FINAL DRAINAGE LETTER

Hotchkiss Commercial Offices, 2290 Old Ranch Road, Colorado Springs, Colorado
Lot 8, Block E, Amended Filing of Springs Crest Subdivision
El Paso County, Colorado

Add PCD File No. PPR203

Riprap B1 Swale

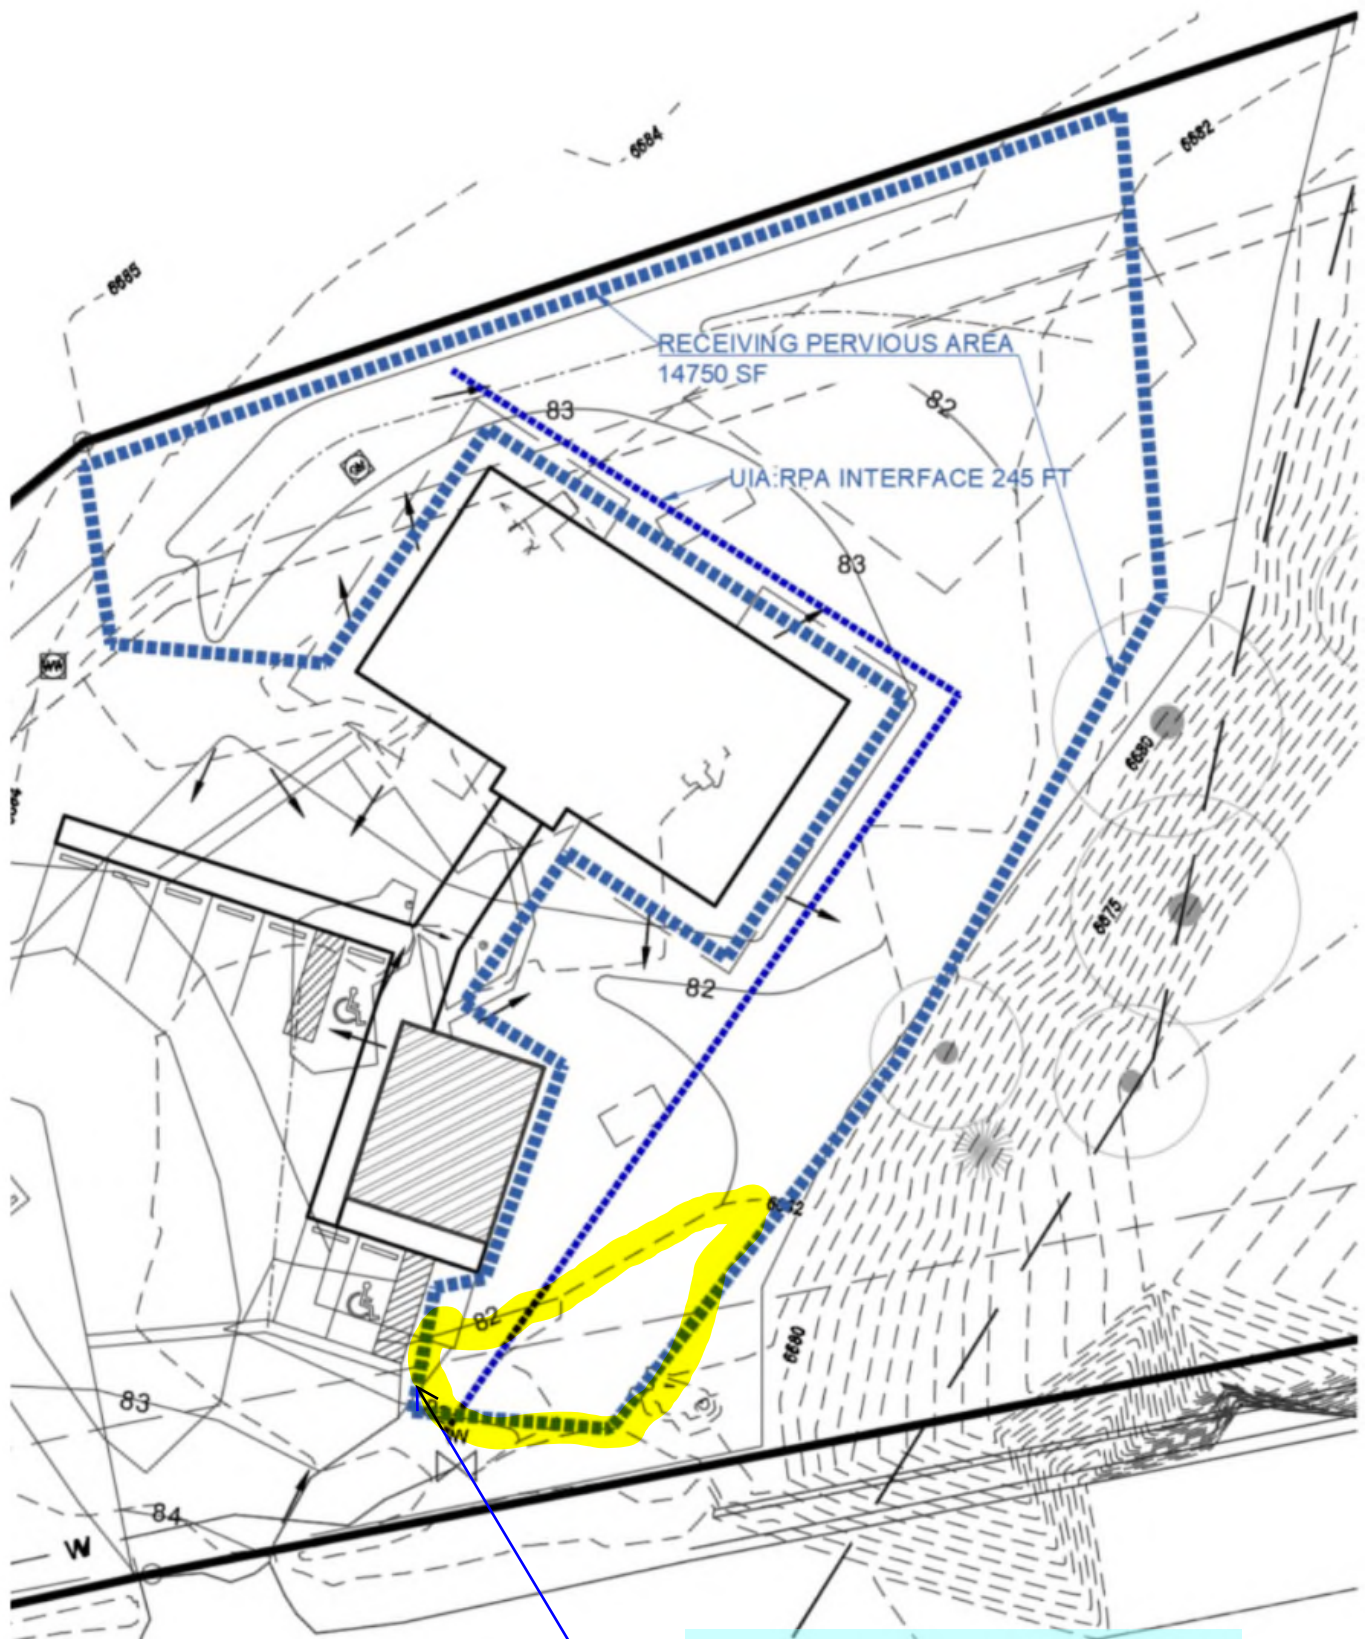
The majority of your impervious area is from the paved parking area which will flow through a small concrete channel and outfall to a small receiving pervious area not the entire area that is shown in this drawing.

FINAL DRAINAGE PLAN
HOTCHKISS COMMERCIAL OFFICES
2290 OLD RANCH ROAD

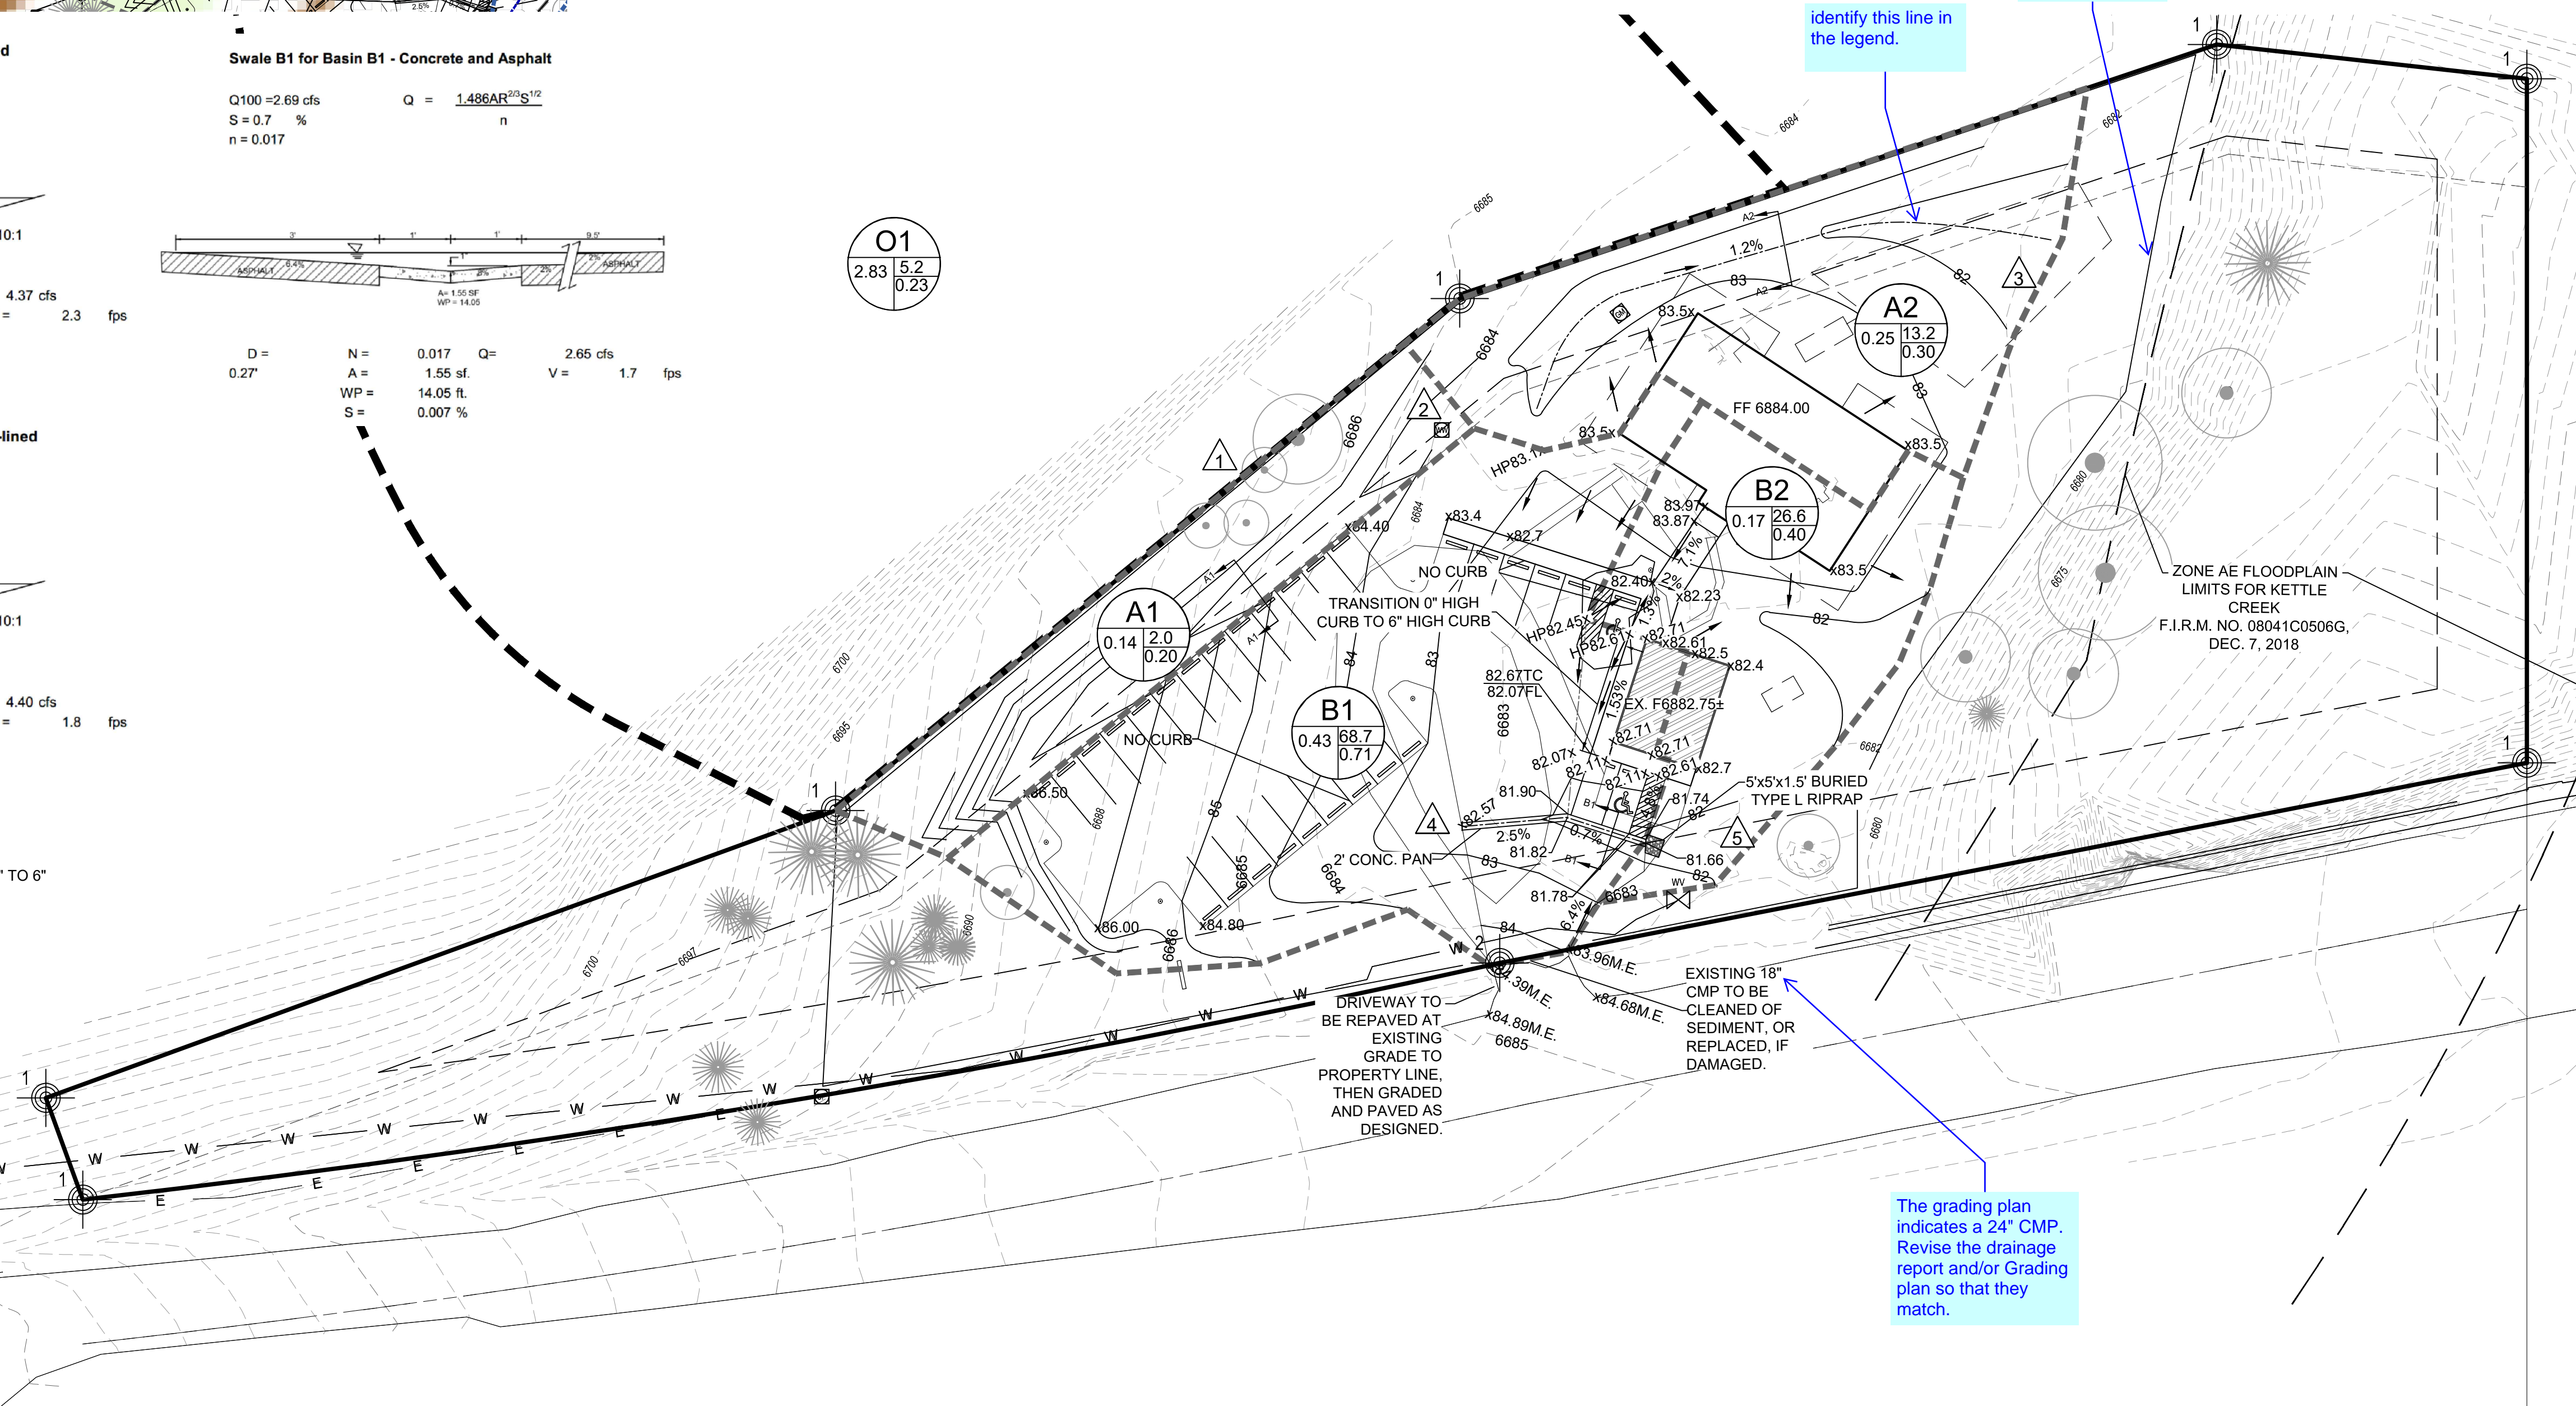
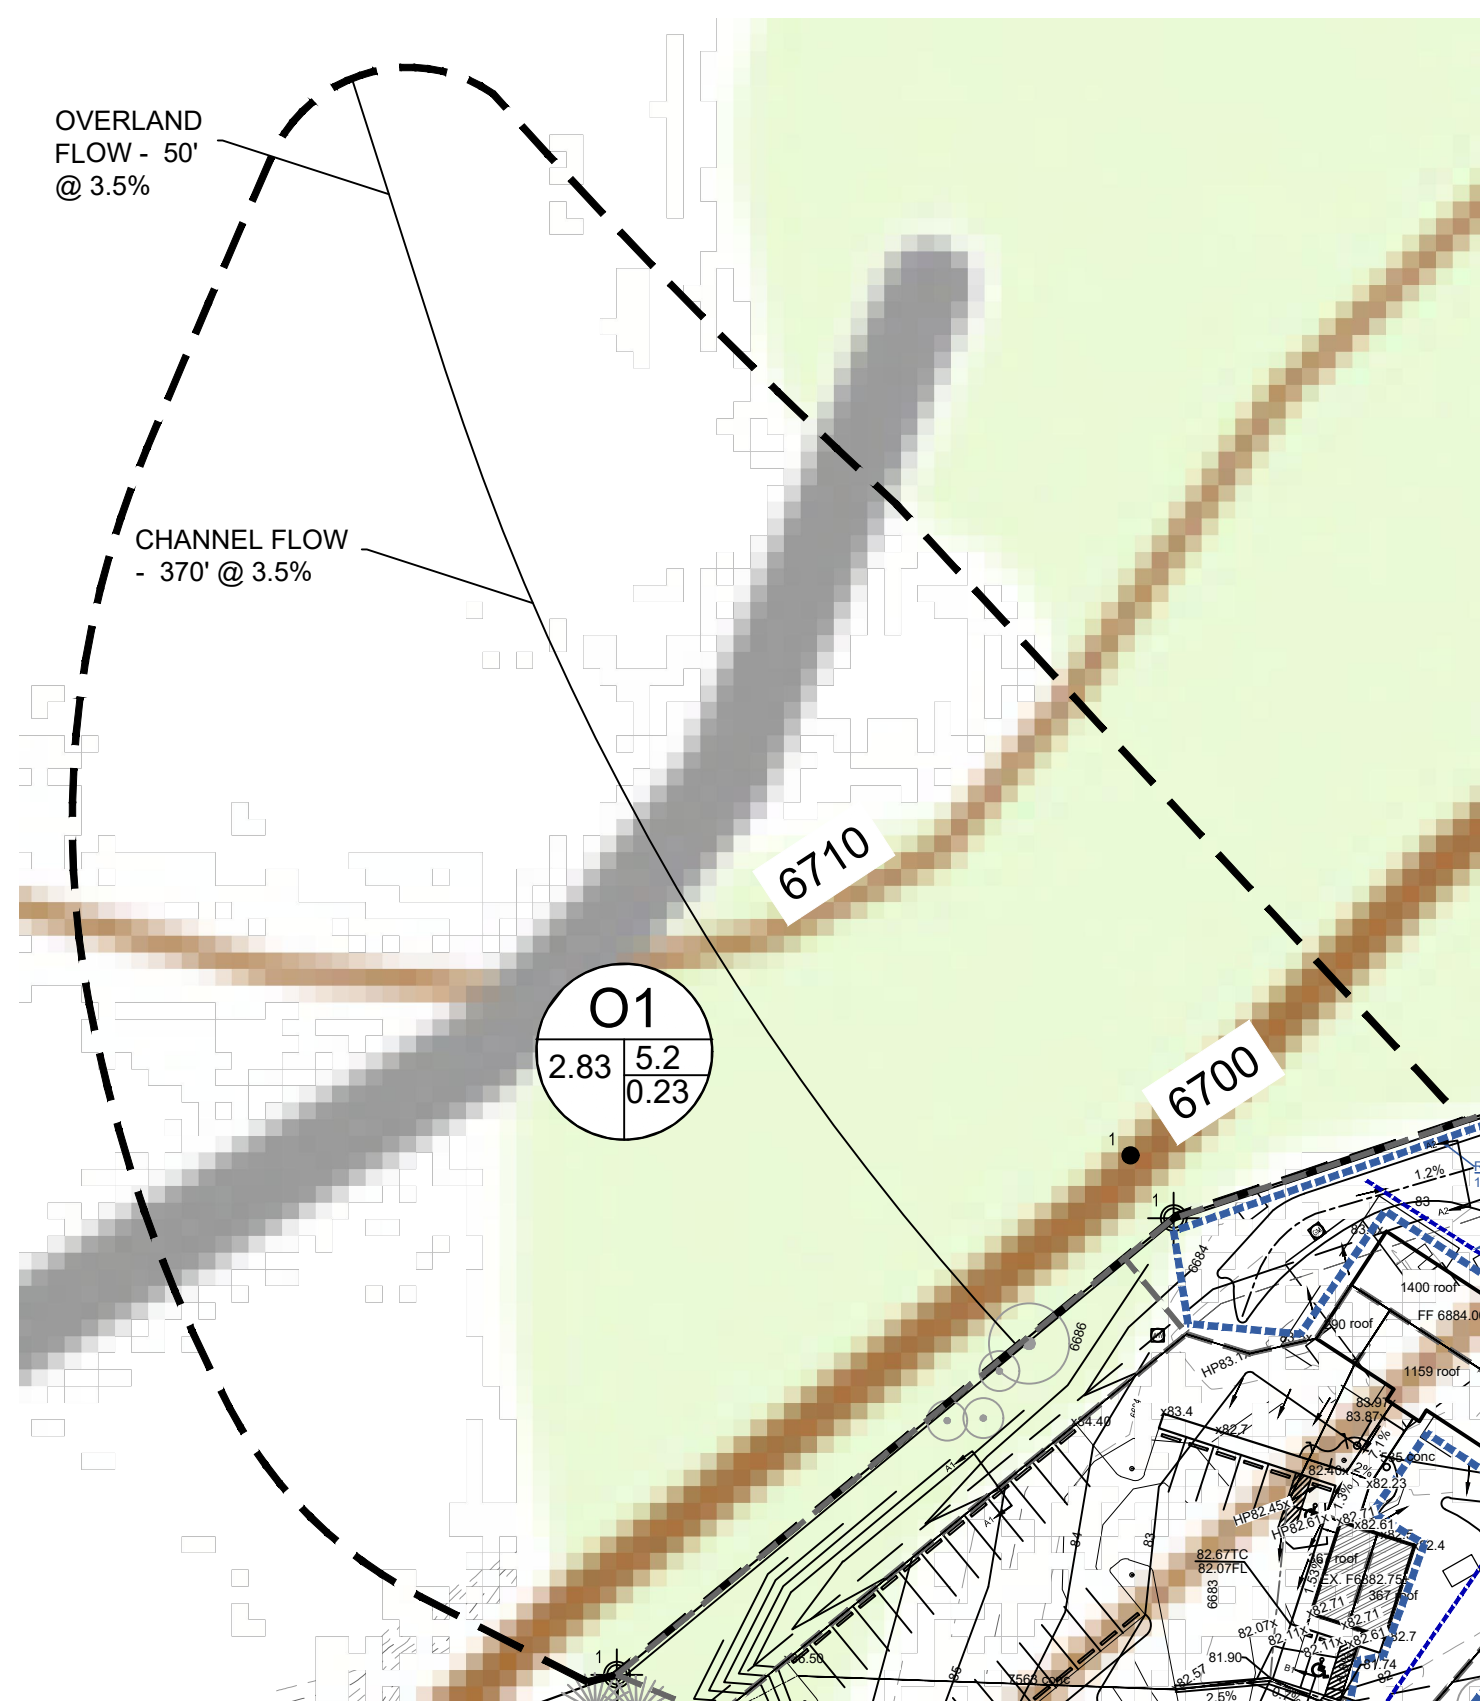
Please elaborate on the existing drainage providing basin descriptions and design points. Also provide an existing drainage plan showing the appropriate basins and design points of existing/historic drainage flow patterns.

Per the existing contours it appears that the flow is going to the east. Revise accordingly.

Provide an explanation as to what this basin is or where this basin is located as it is not shown on the drainage plan.
